## **GARDEN HALLS, UNIVERSITY OF LONDON**

**Crime Impact Assessment (Including Secure by Design Response)**

**April 2013**

Drawn	Date	Scale @ A1/A3	Alt. Ref.
EHG	nov 2012	1:200/1:400	--
tp bennett Project No.	Drawing Number	Rev	
<b>A10417</b>	<b>D 1100</b>	<b>P1</b>

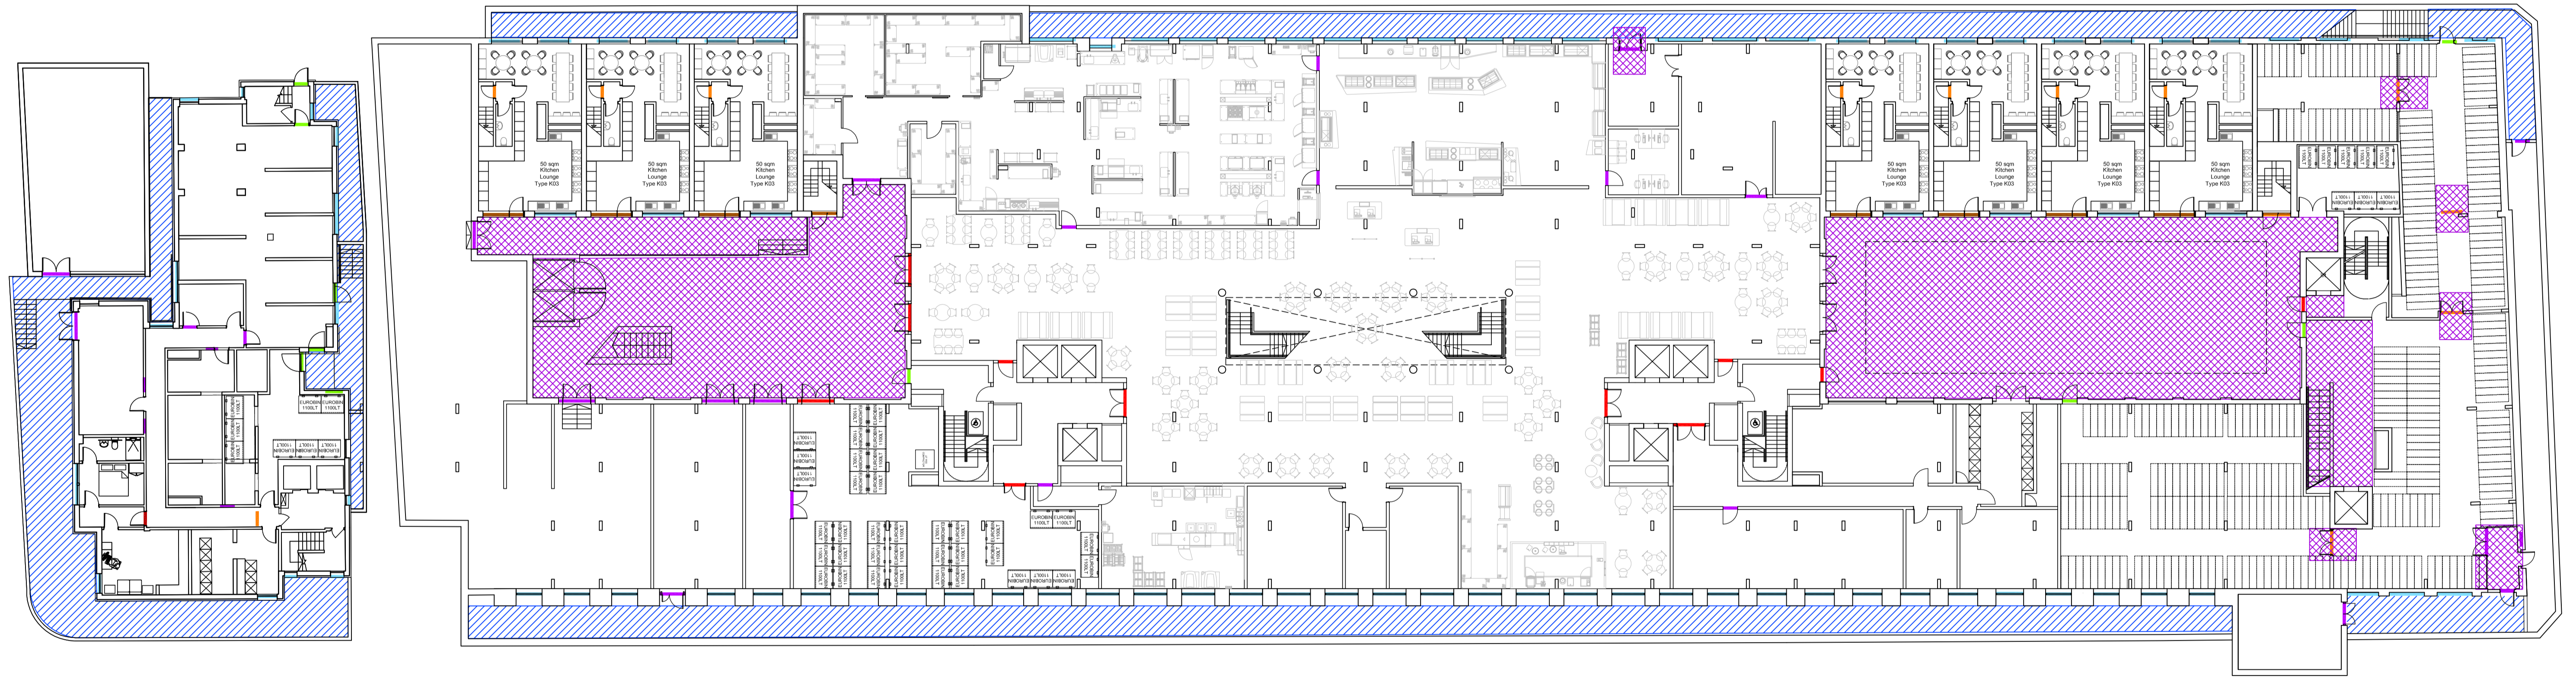
1. Doors - All communal and residential doors will be to BS PAS 23/24 2012. I further require control within the building to be controlled with these doors. This may be off a foyer to restrict further entry into the building and at each floor to achieve the same control.

4. Location of access control doors to be fitted to limit access within the building;
5. Extent of removal of existing exterior security features (Security vanes, metal cages on lightwell windows, perimeter fencing etc) and what will be installed in its place (including standards of security products);
6. Each bedroom door and each communal door to be to BS PAS 23/24 2012.

<p><b>Student Rooms:</b></p> <ul style="list-style-type: none"> <li>• All student rooms will have a solid core laminated timber door fitted with an electronic fob/card access control system.</li> <li>• All bedroom doors will feature an integrated one way spy hole (where necessary a dual height or telescopic variant will be included for accessible rooms). The statutory fire protection requirements and enhanced sound performance criteria (through BREEAM) applied to the student room door design will provide an inherently robust installation.</li> <li>• In response to further feedback from the Crime Prevent Design Advisor the applicant is looking into testing the performance of the bedroom doors to the BS PAS 24-2012 standard.</li> </ul> <p><b>Other External Entrances:</b></p> <ul style="list-style-type: none"> <li>• All external entrances and exits around the site will be covered by CCTV and fire escape exits alarmed with local sounders and integral system notifications delivered at the security desk and management office.</li> </ul> <p>Please also see response to comments on routes within the building (below) and the enclosed drawing (Refs: A10417 D1099, A10417 D1100, A10417 D1102).</p>

<p><i>Each bedroom door and each communal door to be to BS PAS 23/24 2012.</i></p>	<p><b>Please also see response to comments above and the enclosed drawing (Refs: A10417 D1099, A10417 D1100, A10417 D1102).</b></p> <p><b>Following the meeting of 10 April 2013 the applicant is investigating the potential to test the proposed door to the BS PAS 24-</b></p>
